Former Pinewood Hazardous Waste Disposal Facility

Sumter County, South Carolina EPA ID Number: SCD 070 375 985

SUBJ: RCRA Compliance Evaluation Inspection

RCRA Inspection Report

EPA RCRA Site Inspection Report Attachment 1 Leachate Treatment System Process Flow Diagram Pinewood Site Custodial Trust Pinewood, South Carolina EPA ID Number SCD 070 375 985

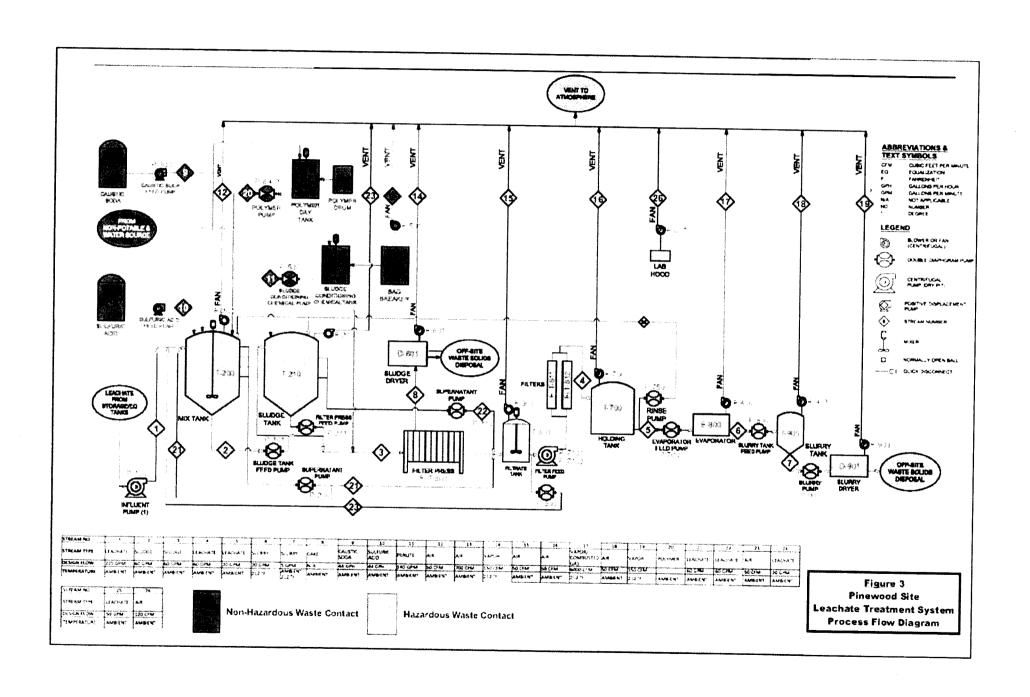
Leachate Treatment System (LTS) Building: "Although the LTS has an air permit, the EPA recommends that the LTS be included in the Post Closure Care Permit as a Miscellaneous Unit (Subpart X) under the S.C. Code Ann. Regs. 61-79.264 [Subpart X of 40 C.F.R. Part 264 (40 C.F.R. Part 264)], and subject to Subpart CC of S.S. Code Ann. Regs. 61-79.265.1080(b)

[40 C.F.R. Part 265] or that it meets any of the exemptions in S.C. Code Ann. Regs. 61-79.265.1080(b) [40 C.F.R. 265.1080(b)]."

At the time of the inspection, all LTS units were properly identified and appeared to be in good condition (pictures 22 and 23). According to the facility's air permit application, all LTS units are vented directly to atmosphere via a common stack in the LTS building. Although the LTS has an air permit, the EPA recommends that the LTS be included in the Post Closure Care Permit as a Miscellaneous Unit (Subpart X) under of S.C. Code Ann. Regs. 61-79.264 [Subpart X of 40 C.F.R. Part 264 (40 C.F.R. Part 264)], and subject to Subpart CC of S.C. Code Ann. Regs. 61-79.265 [Subpart CC of 40 C.F.R. Part 265] or that it meets any of the exemptions in S.C. Code Ann. Regs. 61-79.265.1080(b) [40 C.F.R. § 265.1080(b)]. After the inspection, EPA personnel were informed that the RCRA post closure permit would be amended to include the LTS and the LTS sludge storage area.

<u>PSCT Response</u>: The PSCT is currently revising the Post Closure Care Permit application for the site and intends to include the LTS and the LTS sludge storage area as a Miscellaneous Unit. Prior to the CEI conducted by the EPA, the PSCT has operated the facility with the understanding that the LTS qualifies for an exemption from Subpart CC, as documented in the attached letter from South Carolina Department of Health and Environmental Control (SCDHEC), dated March 21, 2013. However, the PSCT is conducting a new analysis of the regulatory applicability and compliance of Subpart CC, including it exemptions, and is working with the SCDHEC to establish an acceptable schedule for permitting and compliance.

Picture 17: Split seam of secondary containment pad located in the northeast corner of the Central Tank Farm. Picture taken by SCDHEC on 2/22/16.

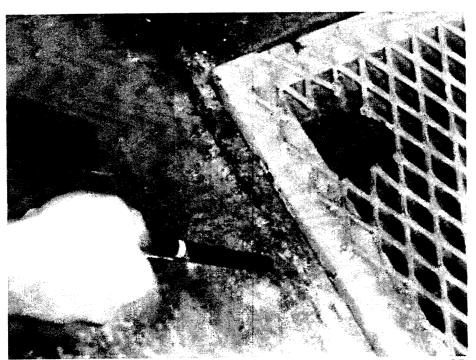
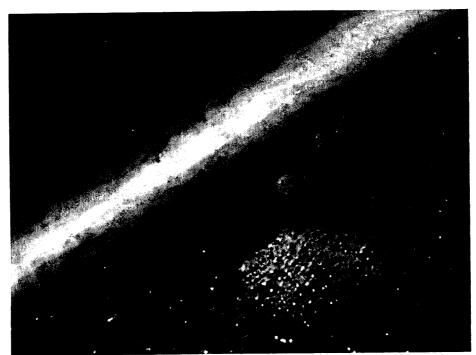
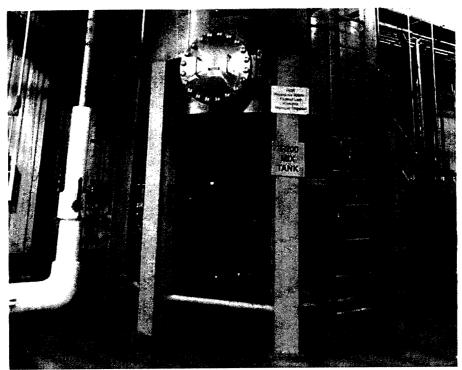
<u>Central Tank Farm (CTF)</u>: "The floor of the tank farm secondary containment system had small spots with cracks in the concrete and the sealant."

All tank openings and manholes appeared to be properly closed (pictures 14 - 16). The floor of the tank farm secondary containment system had small spots with cracks in the concrete and the sealant (pictures 17 - 21).

Pursuant to S.C. Code Ann. Regs. 61-79.262.34(a)(1)(ii) [40 C.F.R. § 262.34(a)(1)(ii)], which incorporates S.C. Code Ann. Regs. 61-79.265.193(e)(1)(iii) [40 C.F.R. § 265.193(e)(1)(iii)], a generator that stores hazardous waste in tanks shall maintain the secondary containment systems of its hazardous waste storage tanks free of cracks or gaps.

<u>PSCT Response</u>: The CTF secondary containment coating was applied in late-2012. The PSCT completed the patch repair of the small spots and cracks in the coating and will continue to monitor for additional cracks in the regular inspections. Should additional cracks be identified, the PSCT will implement additional repairs immediately and document these in the daily inspection reports.
